Report of the Committee on**Fire and Emergency Services Protective Clothing and Equipment****Richard M. Duffy, Chair**

1977-1 Log #101 FAE-WFF (Entire Document)	Final Action: Accept
<p>Submitter: Karen E. Lehtonen, Lion Apparel Comment on Proposal No: 1977-2 Recommendation: Revise text to read as follows: 7.6.2 Goggles shall be tested for optical clarity 8.1.4.6 The radiant heat transducer shown in Figure 8.1.4.6 shall be constructed from sheet copper, <u>as specified in</u> ASTM... 8.4.11.5 A series of points shall be marked 75 mm (3 in.) apart on the outer edge of the peak or brim of the sample helmets, allowing at least three points on a peak and eight of or more points on a full brim. 8.13.5.1.2 Any point with in 100 mm... 8.19.7 <u>Criteria Interpretation</u> 8.21.4.4 The first word in the third line should be overlay not overlap. 8.21.5.1 The word time in the last line is misspelled tme. 8.25.5.3 Test subjects shall be selected such that their hand dimensions are as close as possible... 8.29.6.1 In the fourth line it should say “the eylet or the stud post” not “the eyelet of the stud post”. 8.32.4.2.1(2) the standard abrasive fabric shall be rewetted after each set of cycles

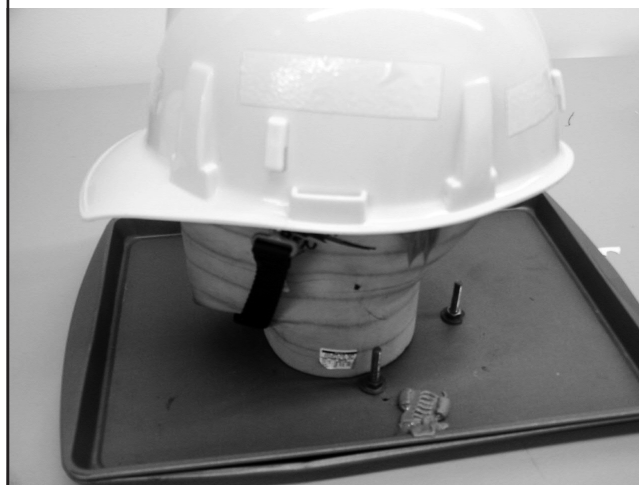
1977-65 (Log #118), Page 32; 1977-66 (Log #165) Page 32; and 1977-67 (Log #176) Page 33: I do not agree with the actions of the committee to reduce the total heat loss proposed in the ROP at 550 W/m² to 450 W/m². The committee failed to consider that the 1998 edition, while requiring a total heat loss of 450 W/m², had these measurements conducted after 5 cycles of laundering. It is well known that laundering causes a decline of total heat

loss for a material system. Therefore, by now moving back to a requirement of 450 W/m² without laundering preconditioning, the committee is effectively reducing the overall breathability of garments as afforded to wildland fire fighters.

It is implausible that barrier clothing such as that specified in NFPA 1951 and NFPA 1999 must meet a total heat loss requirement of 450 W/m² while single layer clothing, which is typically used over longer wearing periods, is expected to meet the same level of performance.
